AGENDA
Regular Hybrid Meeting
Town of Granby
Planning & Zoning Commission
Tuesday, September 9, 2025, at 7:00 pm
Town Hall Meeting Room

a. Application seeking a 7-lot subdivision, Breezy Meadow, for property located at 188 Day Street, R30 and R50 Zones: File P-1-25.

BREEZY MEADOW SUBDIVISION
SITE DEVELOPMENT PLAN
PREPARED FOR
PEAK MOUNTAIN DEVELOPMENT LLC
GRANBY, CONNECTICUT
188 DAY STREET

Sheet SUB-1

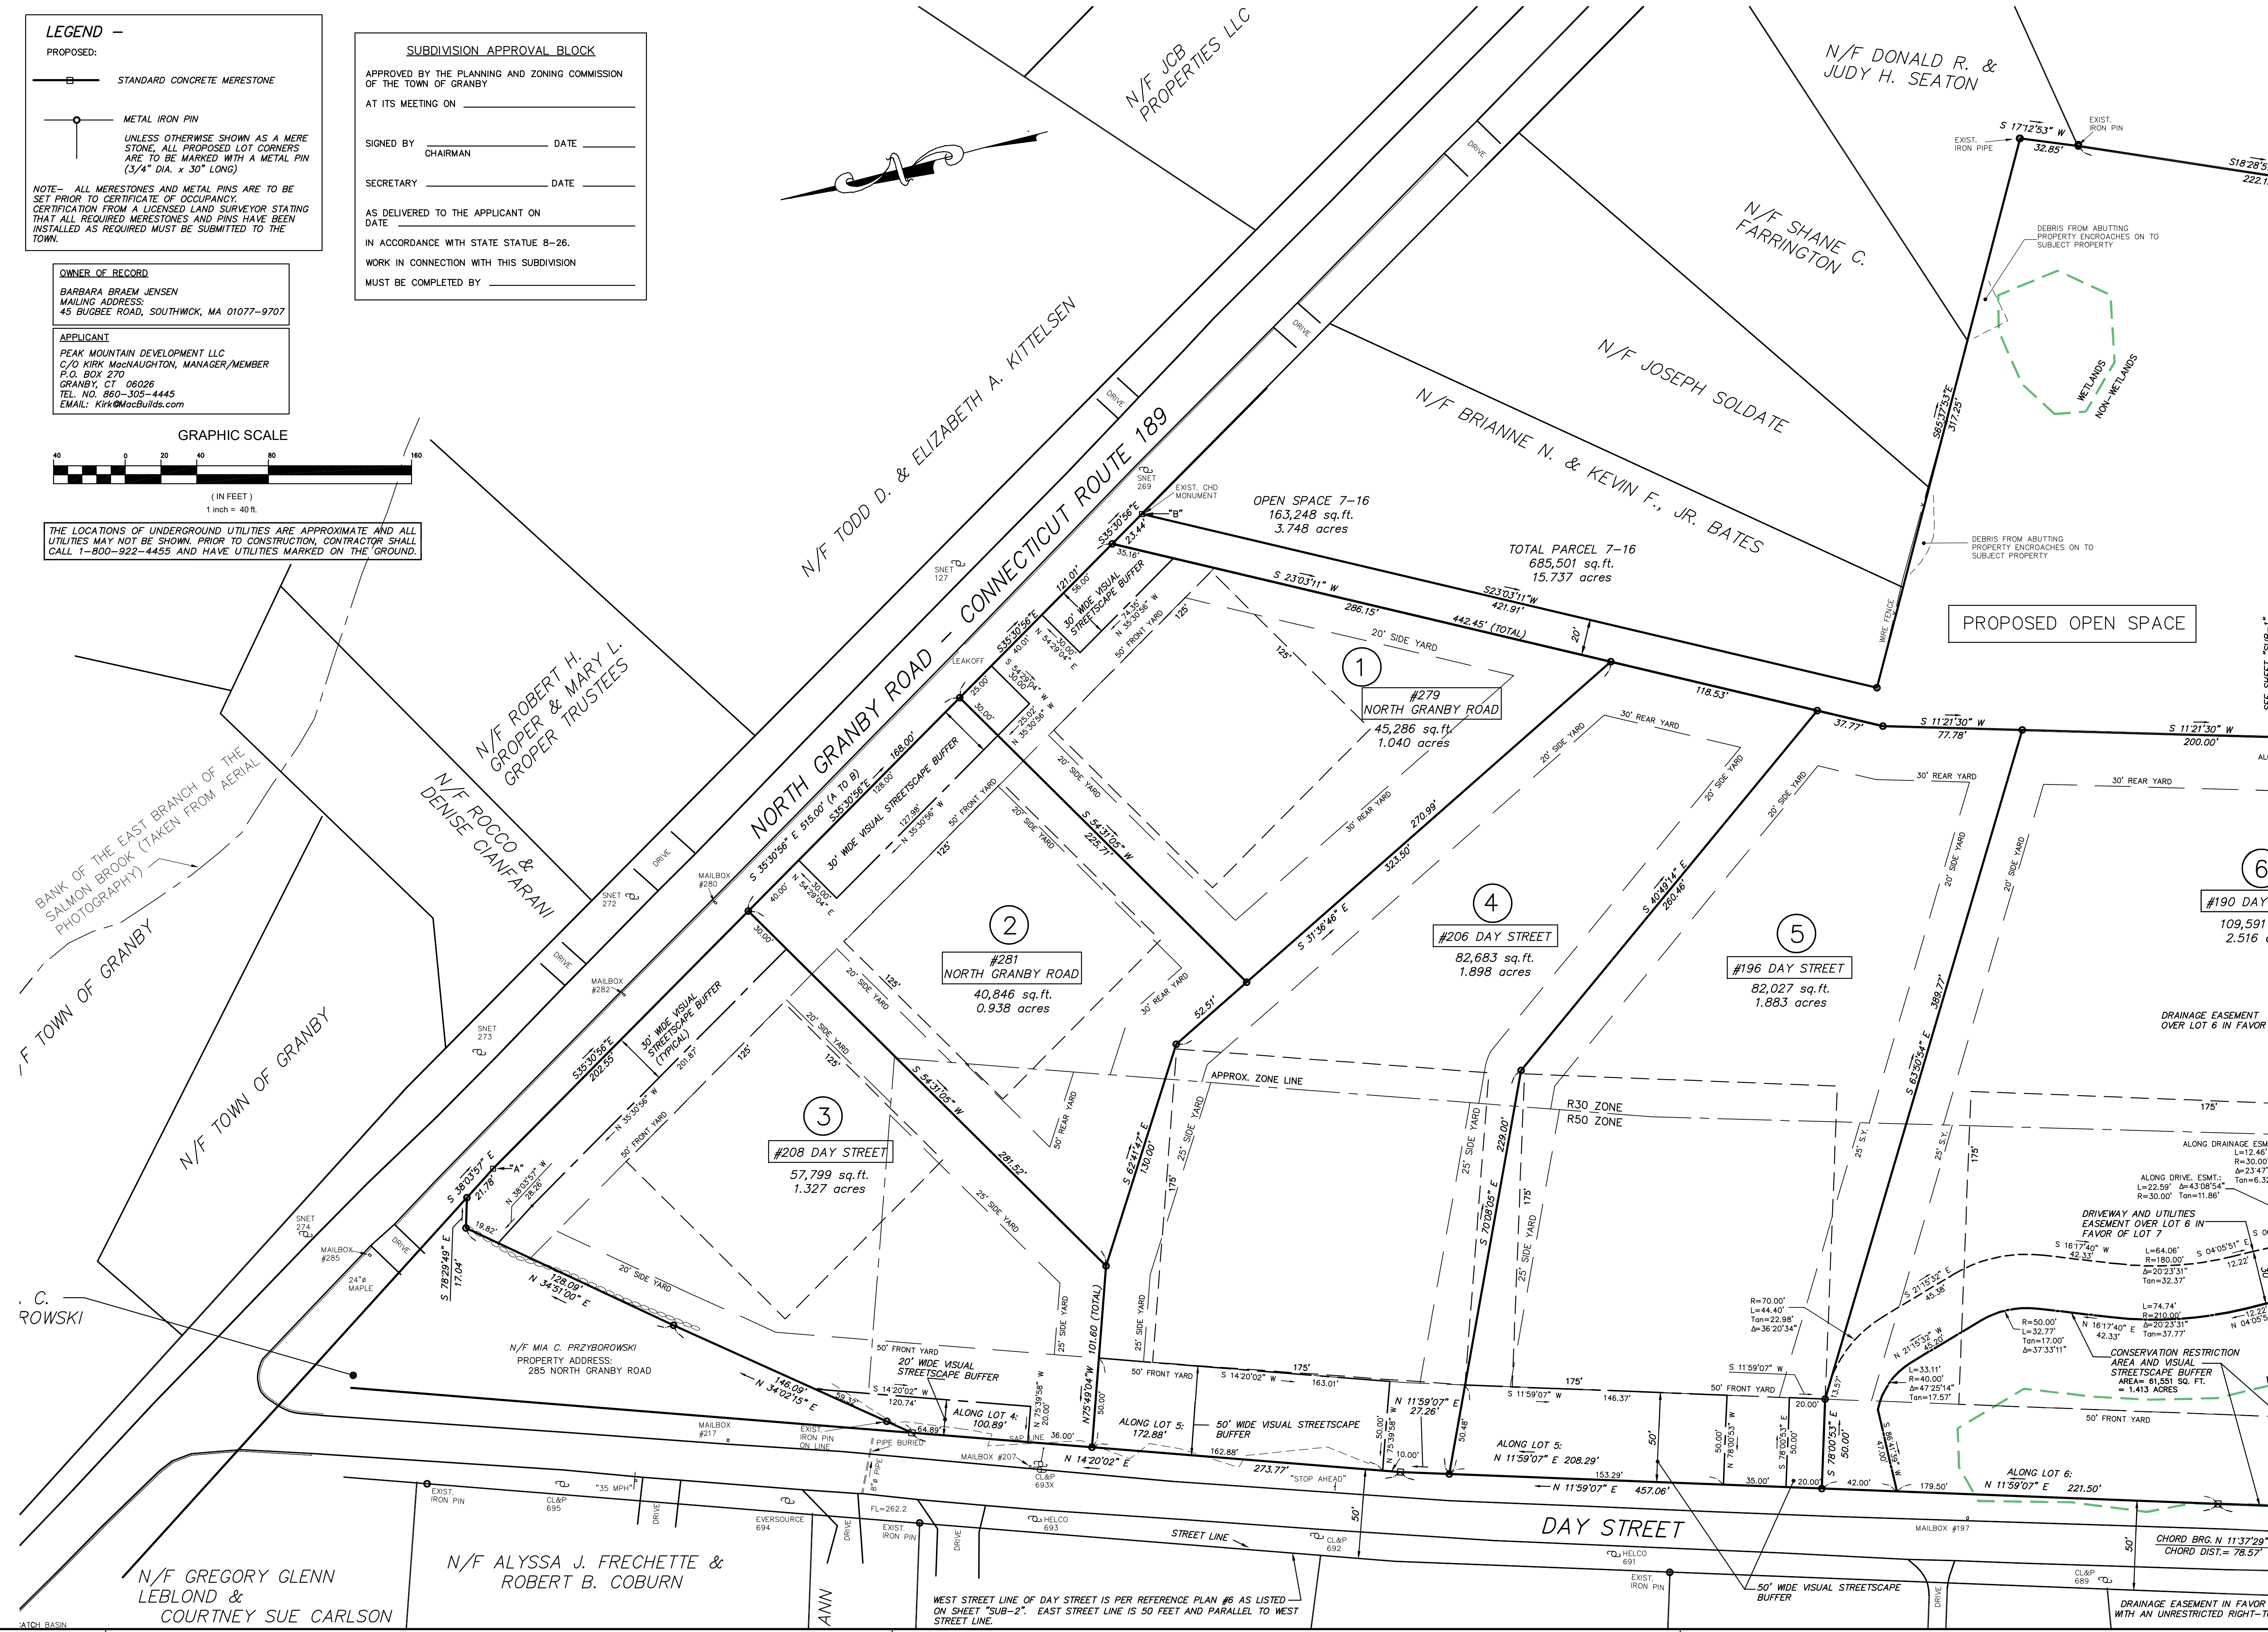
1. Sheet SUB-1: On lots 4 and 5, The visual streetscape buffer has been increased from 30' to 50'.
2. Sheet VPPP-1:

8-26-25
REVISED PROPOSED LANDSCAPING AND WIDTH OF VISUAL STREETSCAPE BUFFERS ON LOTS 4 & 5 FROM 30' TO 50'

Sheet
VPPP-1

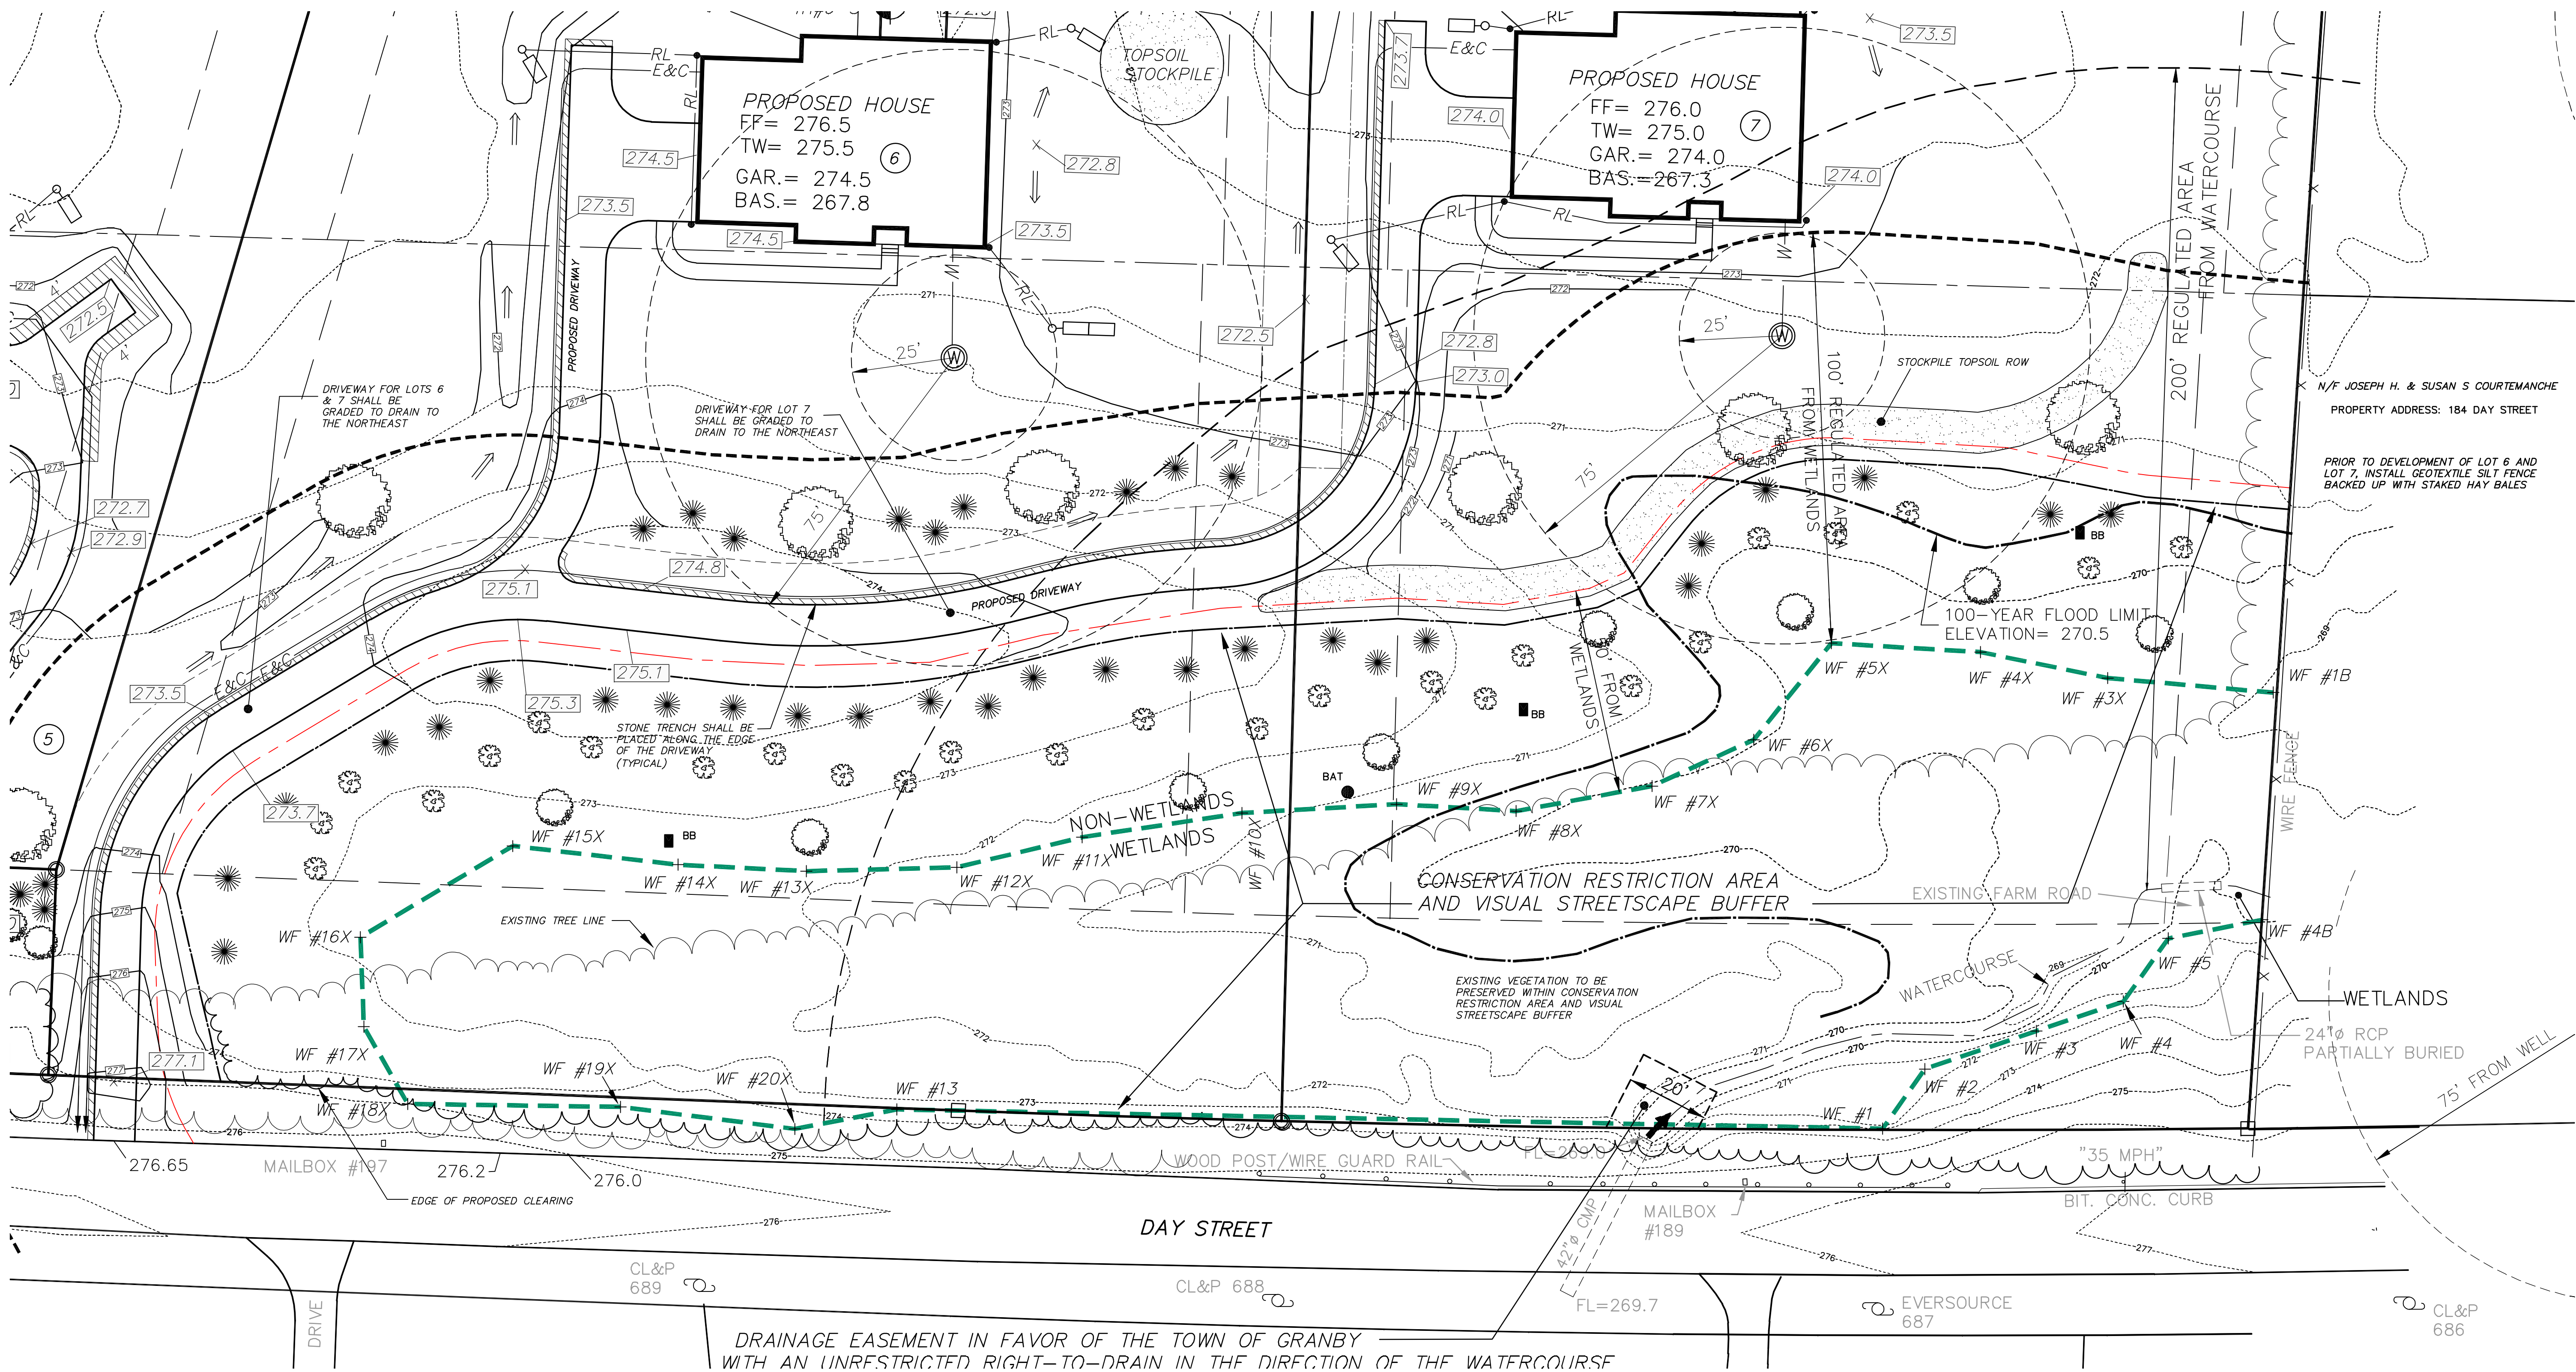
No plantings were shown on previous plan set. The streetscape buffer has been enhanced with the following:

The previous plan set showed 3 red sunset maple (3 ½" caliper). In addition to these trees, the streetscape buffer has been enhanced with the following:

- Removed 11 Norway Spruce (18" tall)
- Added 9 Balsam Fir (18" tall)
- Added 3 Swamp White Oak (1 ½" to 2" caliper)

- Removed 8 Norway Spruce (18" tall)
- Removed 5 Bayberry (18" tall)
- Added 5 Swamp White Oak (1 ½" to 2" caliper)
- Added 5 Bayberry (3-gallon container)
- Added 2 Balsam Fir (18" tall)

REVISED PROPOSED LANDSCAPING AND WIDTH OF VISUAL STREETScape BUFFERS ON LOTS 4 & 5 FROM 30' TO 50'
